Access Compliance Report

Public Rights-of-Way

Intersection ID: 30489	Main Street: BEDDINGFIELD_DR	Cross Street: STONES_LANDING_ST	Location: SW
ADA ID: 8147DFA637AB	Ramp Type: PerpDiag	Initial Pass/Fail: Fail	Overall Compliance: No
Severity Score: 22.5			
Codes/Mitigation Info/Possible Solution		Field Measurements/Component Compliance

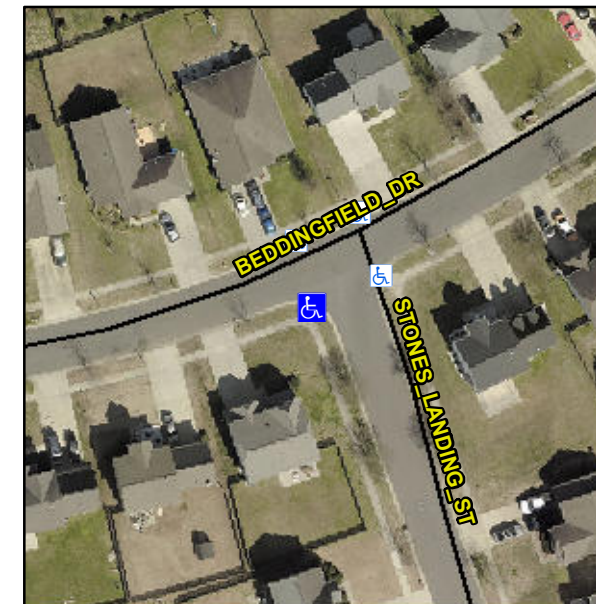
R304.5.1, R304.2.2, R304.5.3

Compliance	Description	Data	Compliance	Description	Data
N/A	Ramp Length (in)	85.0	No	Ramp Slope (%)	9.7
No	Ramp Width (in)	42.0	No	Ramp XSlope (%)	2.3
N/A	Flare Type LT	N/A	N/A	Flare Type RT	N/A
N/A	Flare Slope LT (%)	N/A	N/A	Flare Slope RT (%)	N/A
N/A	Flare Traversable LT?	N/A	N/A	Flare Traversable RT?	N/A
N/A	Landing Length (in)	N/A	N/A	DWS Provided?	N/A
N/A	Landing Width (in)	N/A	N/A	DWS Contrast?	N/A
N/A	Landing Slope (%)	N/A	N/A	DWS Length (in)	N/A
N/A	Landing X Slope (%)	N/A	N/A	DWS Full Width?	N/A
N/A	Landing Curb? (Y/N)	N/A	N/A	DWS Offset (in)	N/A
N/A	Shared Landing?	N/A			
N/A	Gutter Ponding?	N/A	N/A	Gutter Slope (%)	N/A
N/A	Gutter Lip Ht (in)	N/A	N/A	Gutter X Slope (%)	N/A
N/A	Painted X Walk1?	No	N/A	Painted X Walk2?	No
	X Walk 1 Direction	To E		X Walk 2 Direction	To N
N/A	X Walk 1 Width (in)	N/A	N/A	X Walk 2 Width (in)	N/A
	X Walk 1 Slope (%)	0.8		X Walk 2 Slope (%)	4.5
	X Walk 1 X Slope (%)	2.2		X Walk 2 X Slope (%)	0.8

Remove & Replace Curb Ramp With Two New Directional Ramps or Equivalent.
